Watercare Services Limited

Central Interceptor Main Project Works Section 92 RMA Response Report May 2013

On 8 April 2013, Auckland Council requested further information under Section 92 of the Resource Management Act 1991 (RMA). Watercare's response to that request was provided on 13 May 2013 in the report titled "*Central Interceptor Main Project Works – Section 92 Response Report to Auckland Council*" dated 13 May 2013. As noted in that report, there were some matters still requiring a response. These are addressed in this letter and the attachments.

Mt Albert War Memorial Reserve Updated Drawing

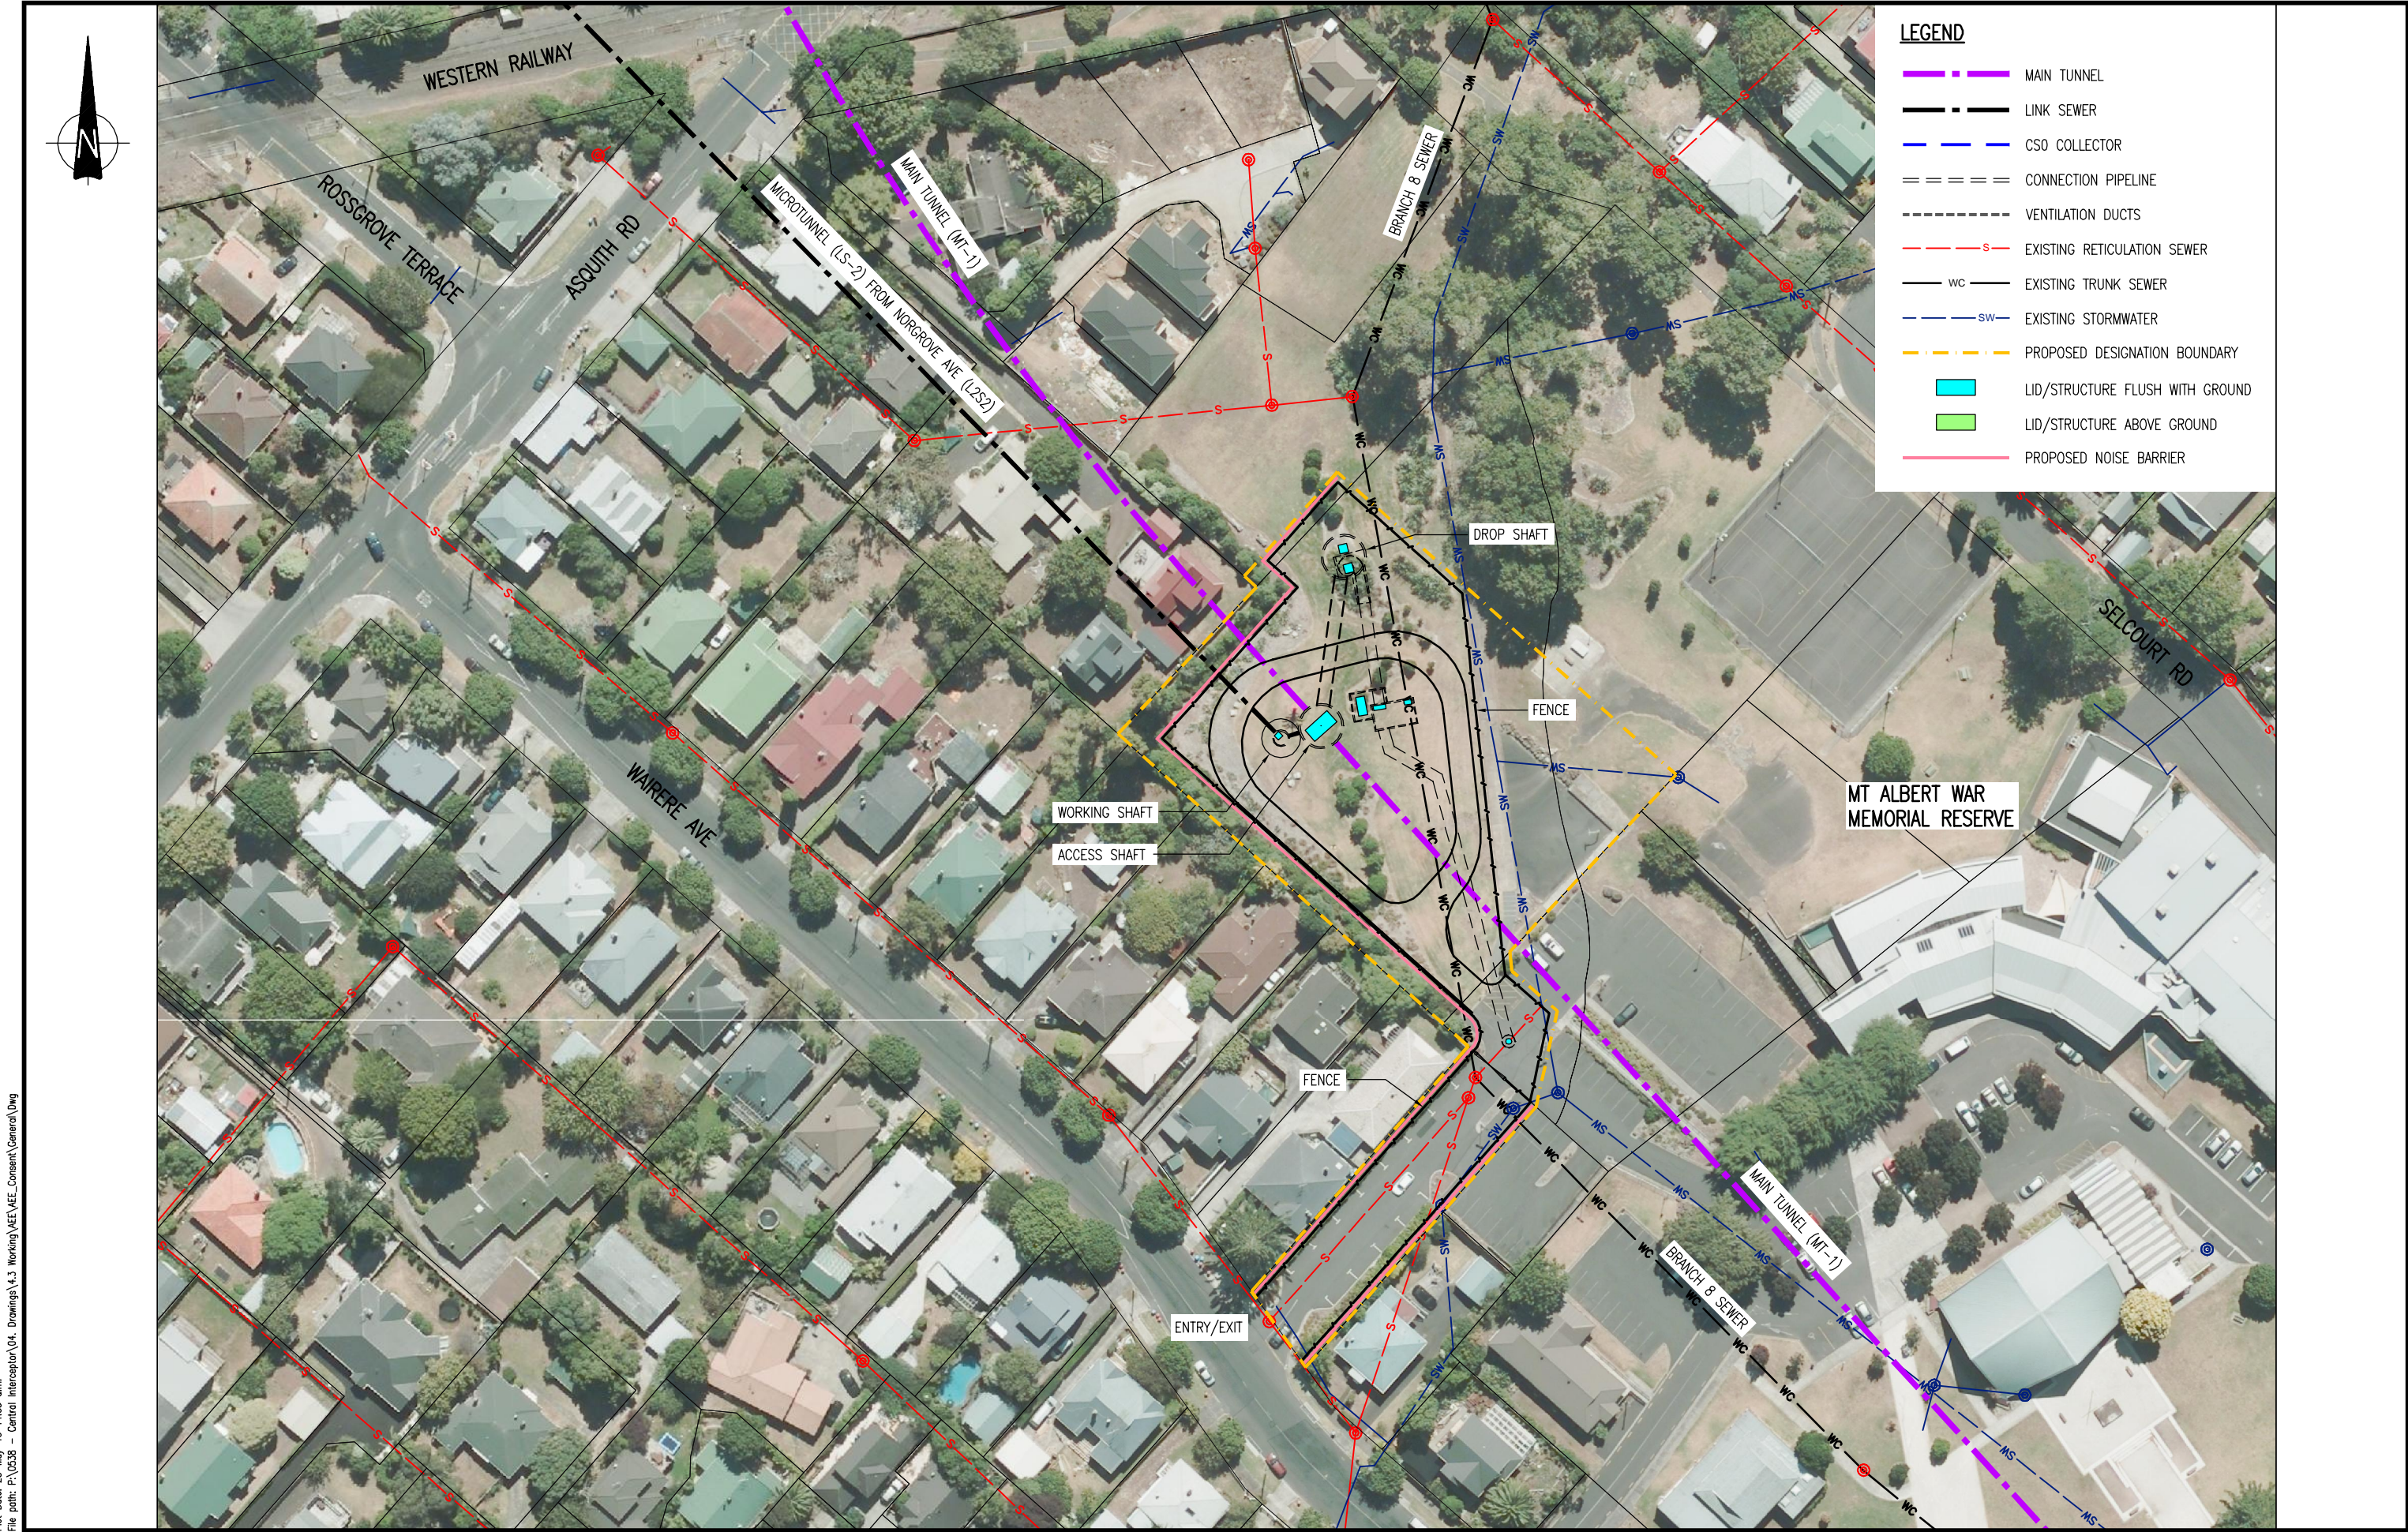
The original construction layout for the Mount Albert War Memorial Reserve (as set out in Notice of Requirement 1) included noise barriers around the site, but not along the construction access road from Wairere Avenue. We now proposed to include noise barriers along the construction access road. The updated drawing AEE-MAIN-2.2 Issue B is included in **Attachment 8**.
